**Re: DART+ WEST ELECTRIFIED RAILWAY ORDER 2022
CASTLETHORN AND CHARTERED LAND GROUP SUBMISSION WITH RESPECT
TO THE IMPACT OF THE ASHTOWN ROAD IMPROVEMENT WORKS ON OUR
LANDS AT ASHTON HOUSE.**

ASHTOWN ROAD UPGRADE & ENTRANCE TO ASHTON HOUSE

Architectural Heritage Impact Assessment of the Proposed Alternative Entrance Route to Ashton House, Ashtown, Co. Dublin

Figure 12: Plan of the OMP proposed alterations to Ashton Road, with the existing conditions overlaid in red. Drawing prepared by OMP Architects.

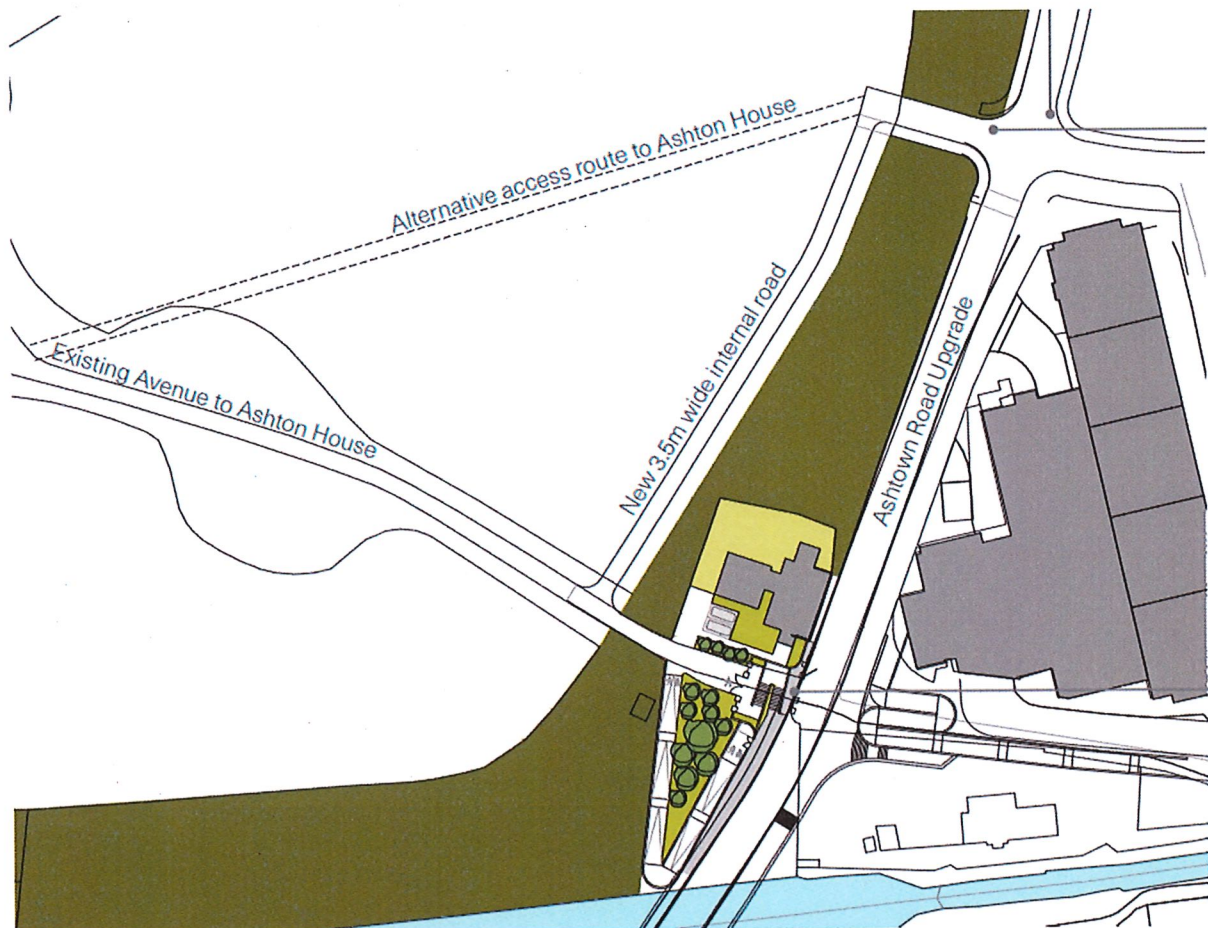
The entrance gates and piers will be relocated to the west, at the top of the proposed new ramp/steps. This will ensure that the relationship between the gates/gate piers and the entrance avenue remains largely intact and will preserve views from the gateway along the

The proposed new vehicular entrance and avenue will cut through the parkland to the north of the existing entrance avenue. There are no outbuildings or ancillary structures in this area, ensuring minimal impact on the historic fabric of the estate. This location for the new avenue also ensures that the primary views and areas of greater significance within the parkland will not be impacted. The route of the proposed new entrance route is therefore considered to be an acceptable and appropriate alternative.

Figure 13: 3D model showing Option B, proposed by OMP and Castlethorn. Prepared by OMP Architects

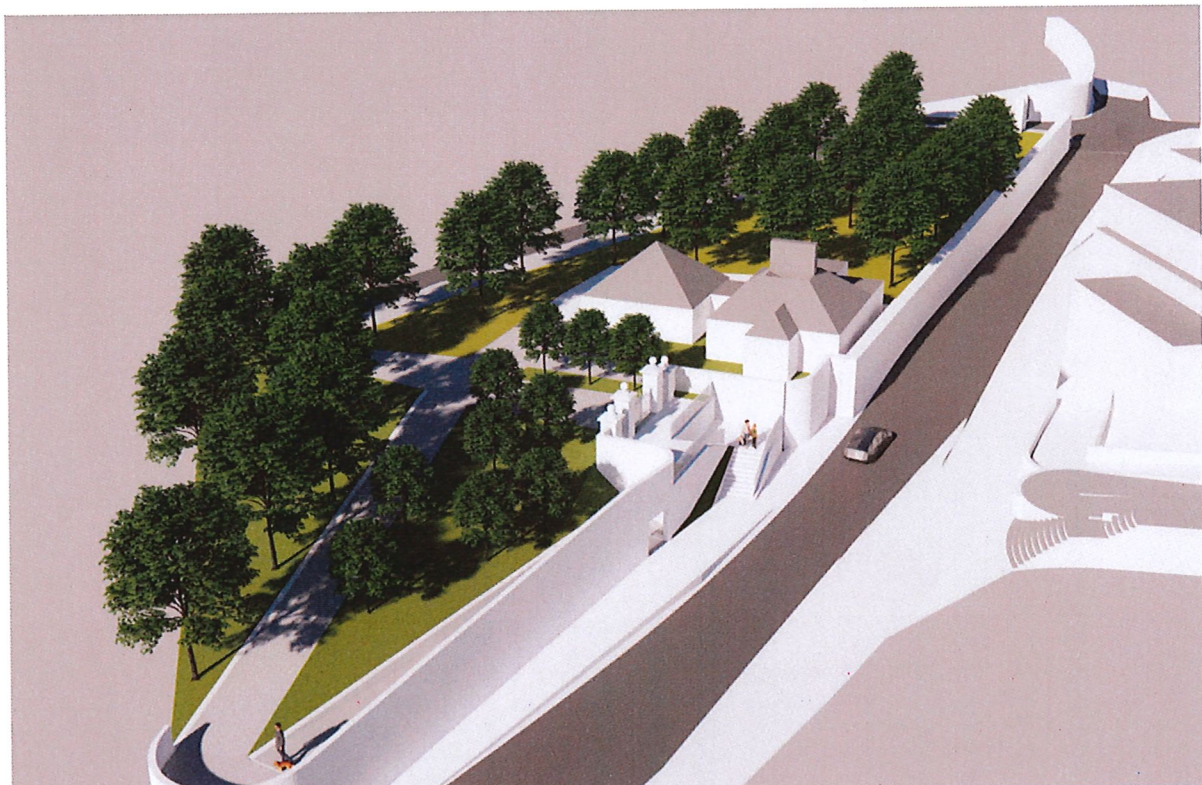
Option B will nevertheless irreversibly alter the relationship between the historic estate and the streetscape of Ashtown Road, severing views from the public realm into the estate lands. However, in the context of a necessary infrastructural intervention, the proposal can be seen as far less impactful than the existing proposal.

A detailed conservation specification and method statement for salvage, relocation, repair of all of the stone and iron elements should be agreed with the Planning Authority and

conditioned to ensure that the fabric and character of the entrance and gate lodge are enhanced by the works.
